**STAFF REPORT: 3/8/2023 REGULAR MEETING**

**APPLICATION NUMBER: #23-8201**

**ADDRESS: 761 WHITMORE**

**SCOPE: INSTALL VINYL WINDOWS, (WORK COMPLETED WITHOUT APPROVAL)**

Figure 2, by BSEED e-Plans BLD2019-06541: East Courtyard (East) north elevation, showing where brick wall was rebuilt and some of the window openings, along with the elevation key notes that state brick to match existing penetrations.

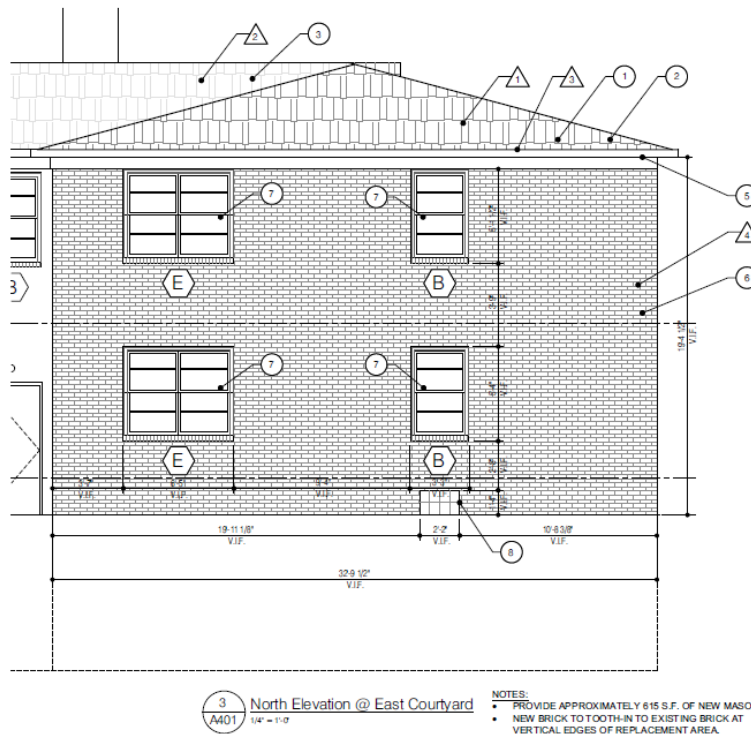
- Staff issued a COA in 2019, which states that the brick wall at the North Elevation at the East Courtyard to match existing and the associated signed BSEED permit BLD2019-06541 which states that: “Exterior Openings: Areas in which window and door openings are to be framed shall match the size and location of the original openings that they are replacing...” and associated approved drawings A401, A402, A403 show notes that state “New masonry wall brick to match existing, window penetrations to have rowlock sill to match existing. New wall to have soldier course, match existing. Tooth in brick where new masonry meets existing masonry.” Despite the drawings, and COA issued, staff observed that the construction of these 19 window openings that were damaged by fire, they were not constructed to their approved original size. Therefore, staff observes, the windows may match in dimensions to the other windows, but the window openings, do not and lack the space to accommodate the brick moulds. This work adds to the violation status of the property. (See figures 2-3).

- The lost brick moulds of the recreated 19 window openings were not completed by the approved 2019 COA and permitted drawings and destroyed the original dimensions and craftsmanship of the original wood brick moulds.
